Subject: Oconee Nuclear Station  
Docket Nos. 50-269, -270, -287  
Response to Request for Additional Information on  
the Oconee Emergency Power System

REQUEST FOR ADDITIONAL INFORMATION  
OCONEE EMERGENCY ELECTRICAL POWER  
DISTRIBUTION SYSTEM

Graphs of 3LP-17 Current During Test 6

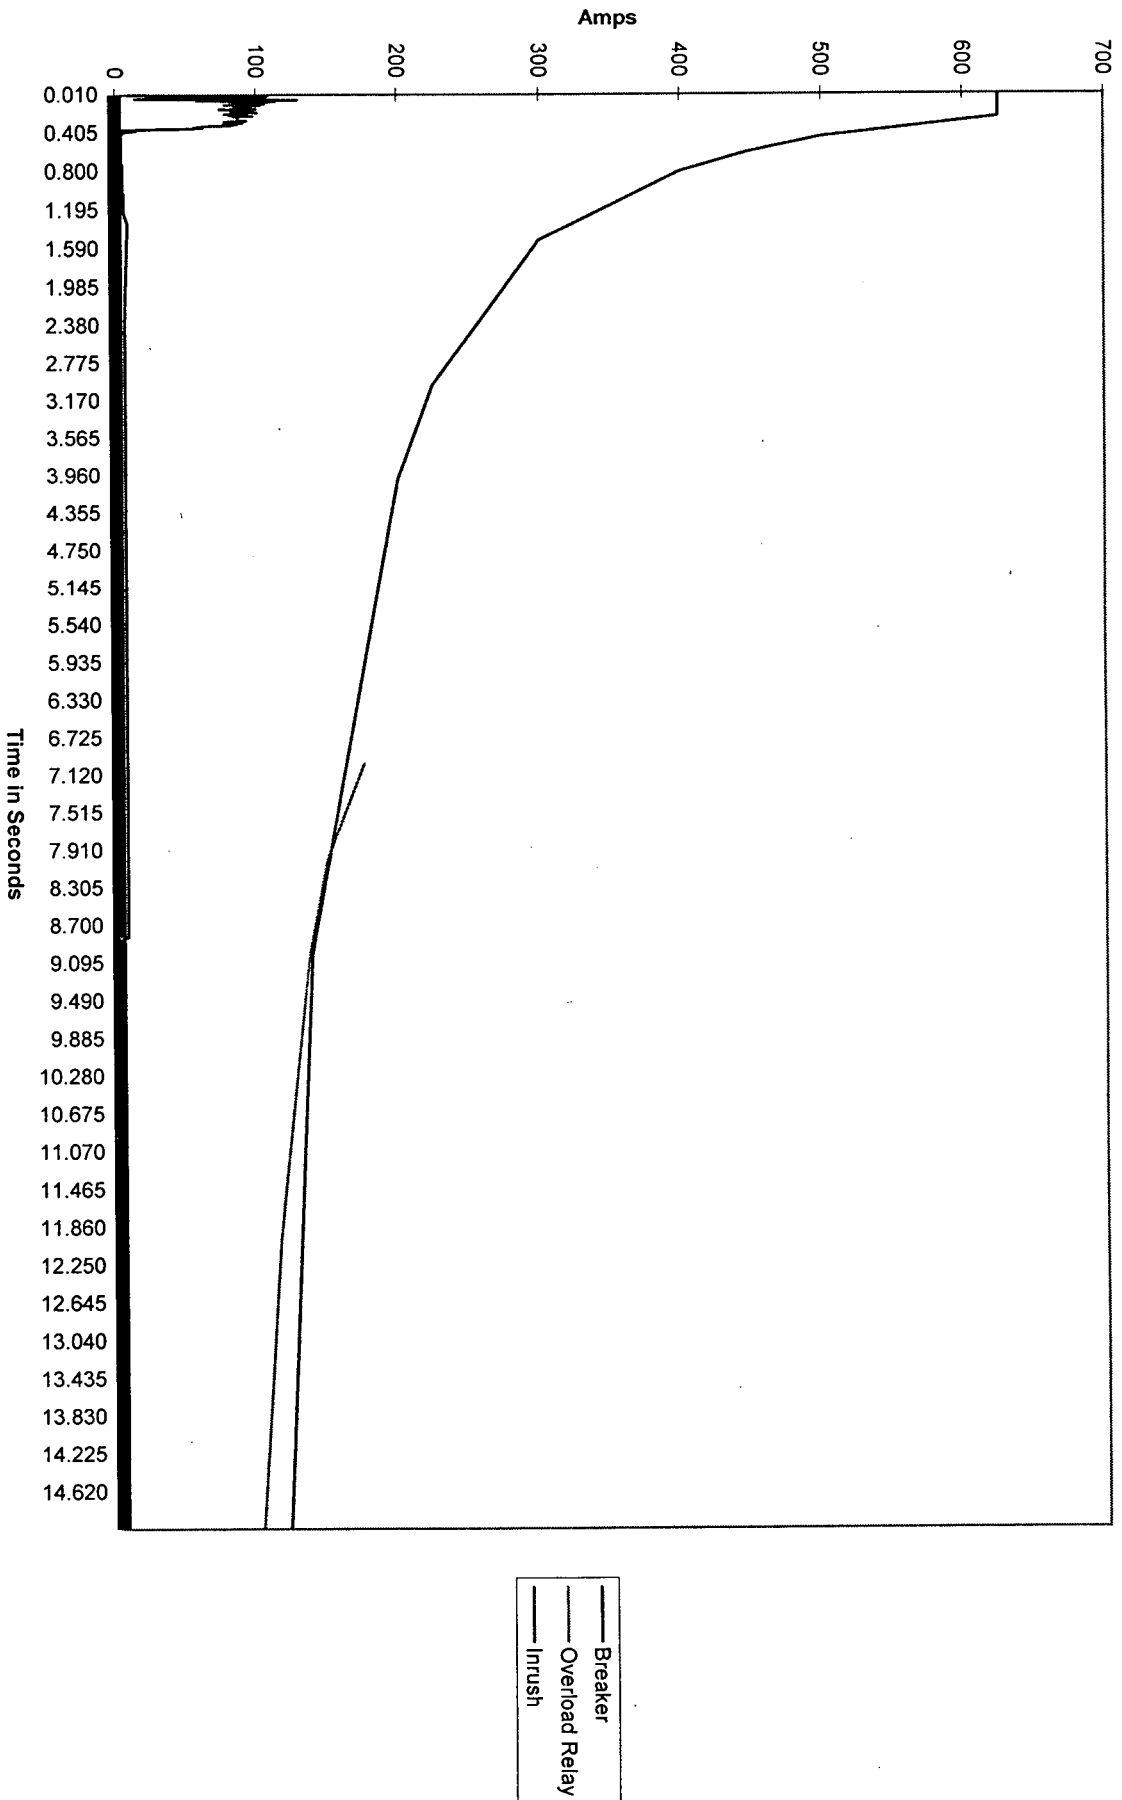
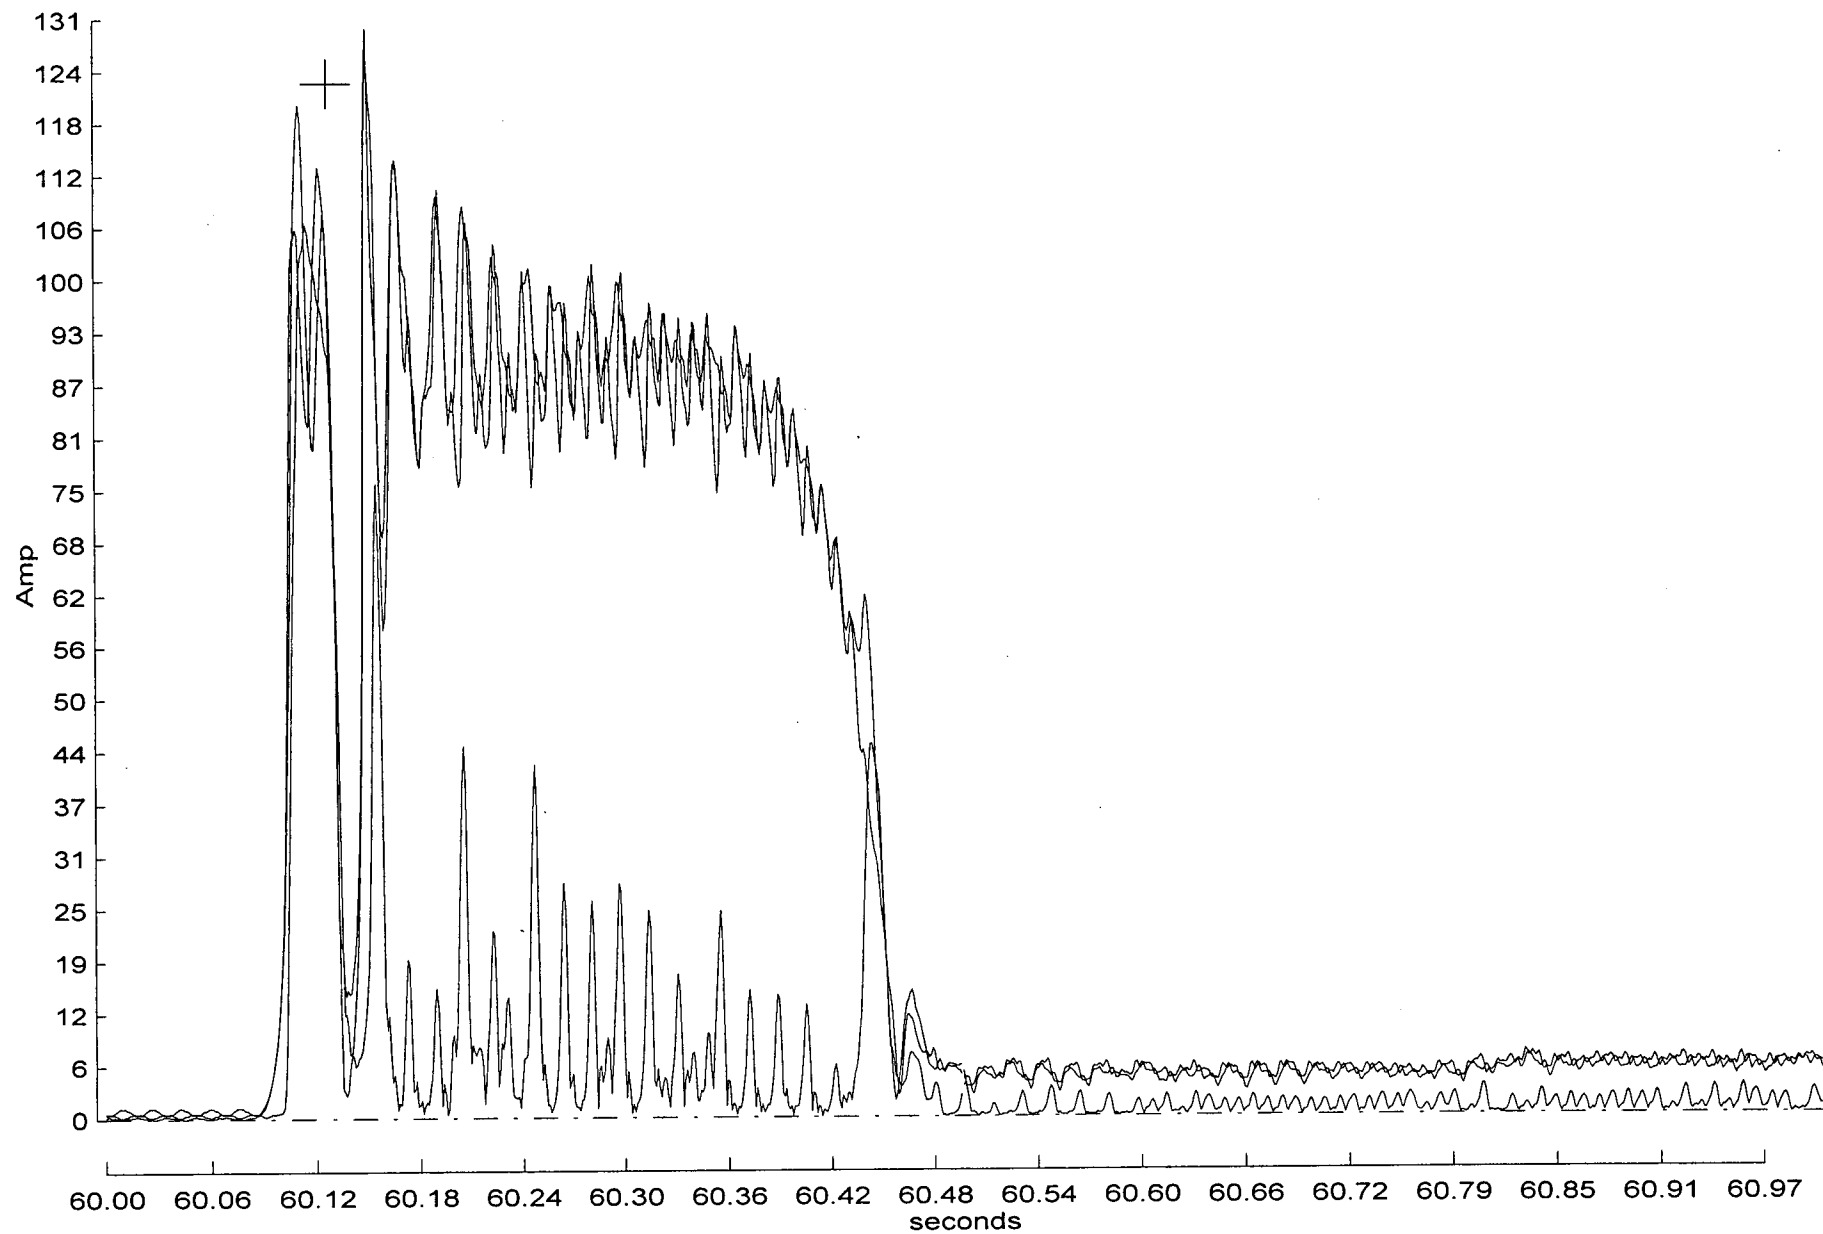
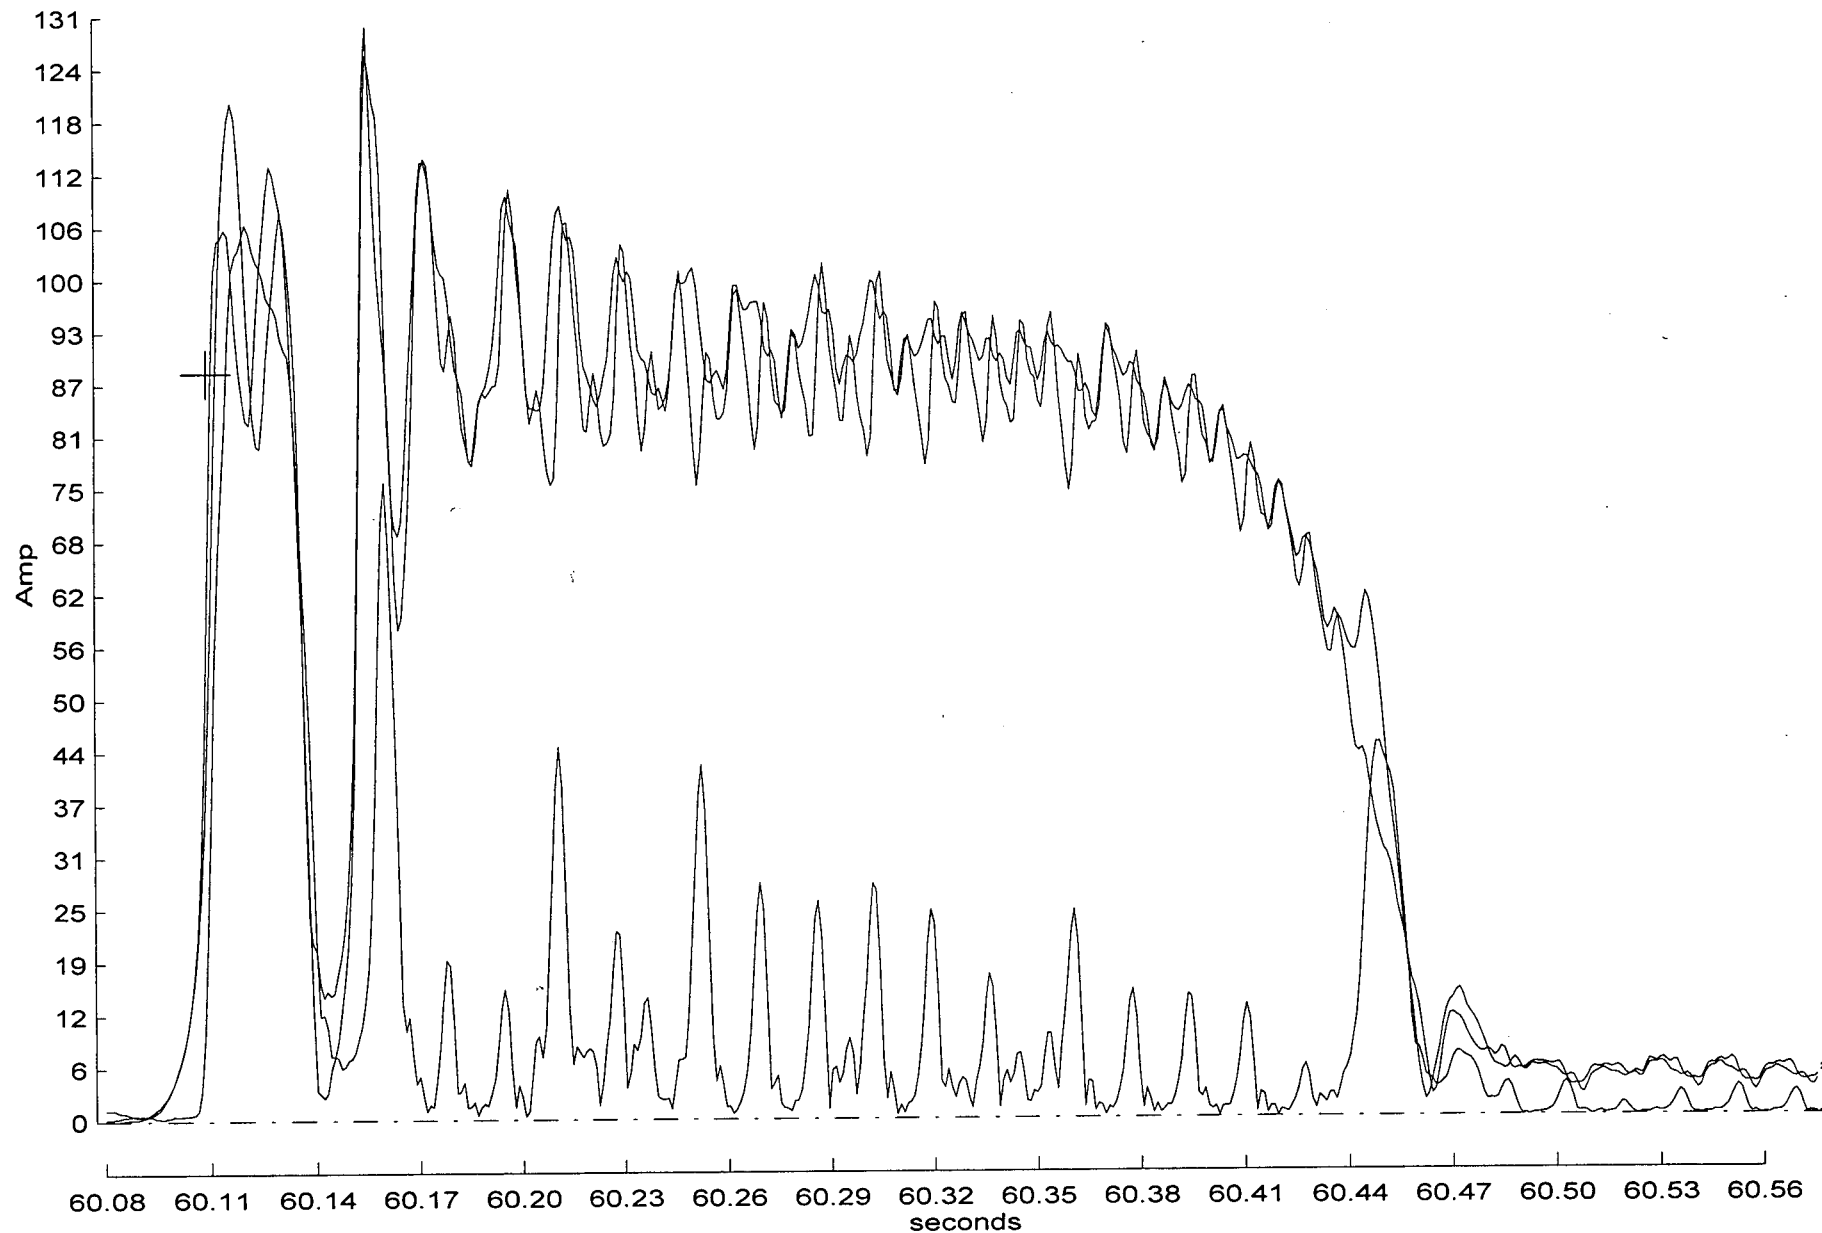
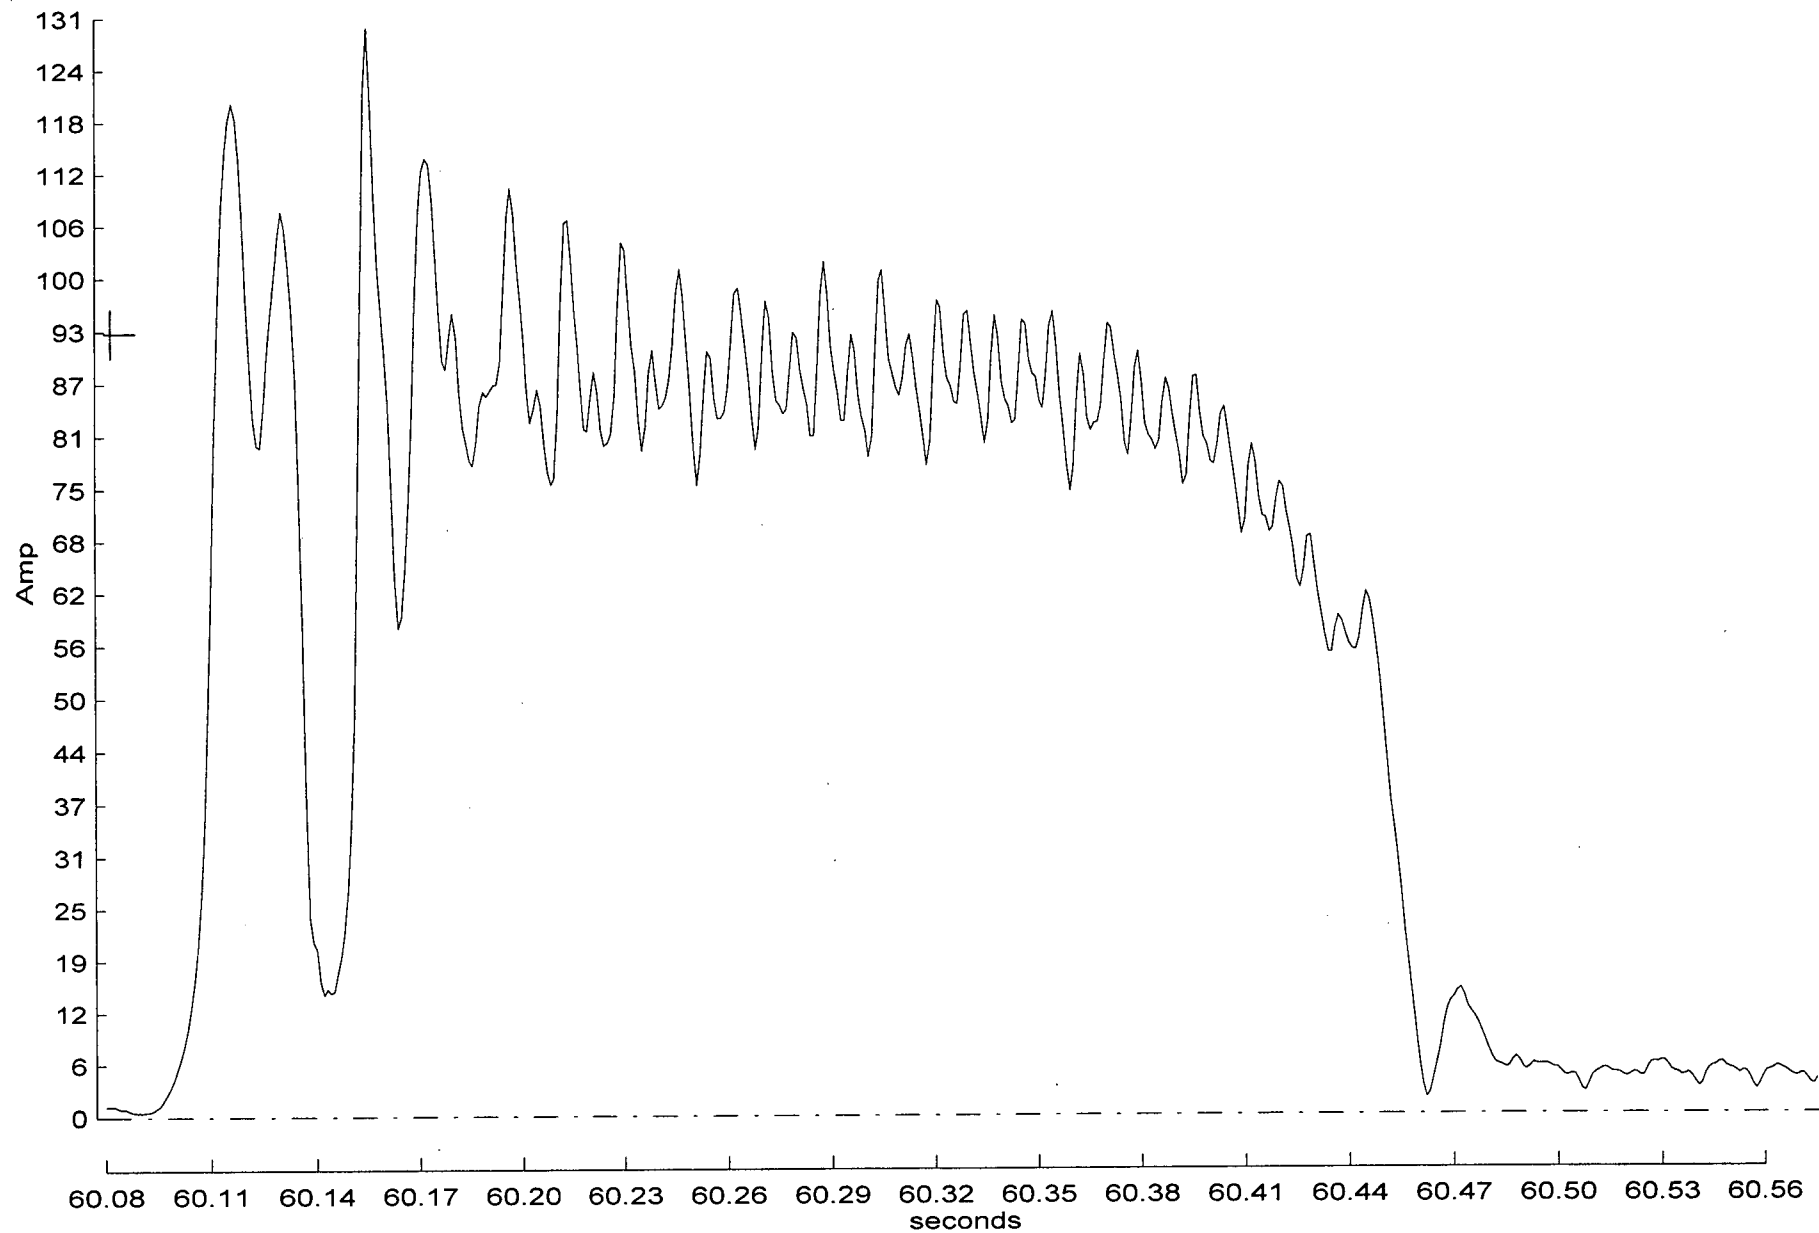
7. Section 5.2.4 of the report states that MOV 3LP-17, which is a gate valve, briefly stalled while starting following contactor pickup during Tests 4, 5, and 6. The stall times were 1.0, 1.0, and 0.4 seconds, respectively, for the three tests. The report indicates that the valve recovered in each case and completed its stroke to its proper ES position; and following inrush, valve stroke was normal and normal hammer-blow and unwedging was observed. We note that in all the LOCA tests where the MOVs are actuated, this particular valve's motor contactor picks up at a voltage value that is quite often one of the largest values seen on the group of valves that are monitored. On that basis, not considering any other variables, it would be expected that this valve would be the least likely to stall.

- d. Please provide plots of the valve motor's thermal capability and overload protection, overlaid on the starting inrush current figures shown for this valve during the tests.

monitored phases was analyzed for inclusion in the report since all valve stroke events could be identified regardless of which phase was analyzed. A more detailed review of the data for all three monitored phases indicates that the primary reason 3LP-17 appeared to stall was that the 'c' phase starter contact chattered while the 'a' and 'b' phase contacts maintained a stable energized state. Therefore, the 'a' and 'b' phases (one of which was included in the report) indicated stall conditions until the 'c' phase contact maintained a stable energized state. Once all three phases were energized, 3LP-17 stroked as expected. In retrospect, 3LP-17 did not actually stall as originally thought. Attachment 6 contains the plots of the current data for 3LP-17 which indicate the chattering of the 'c' phase contact.

Copies of the requested plots are contained in Attachments 2 through 6.
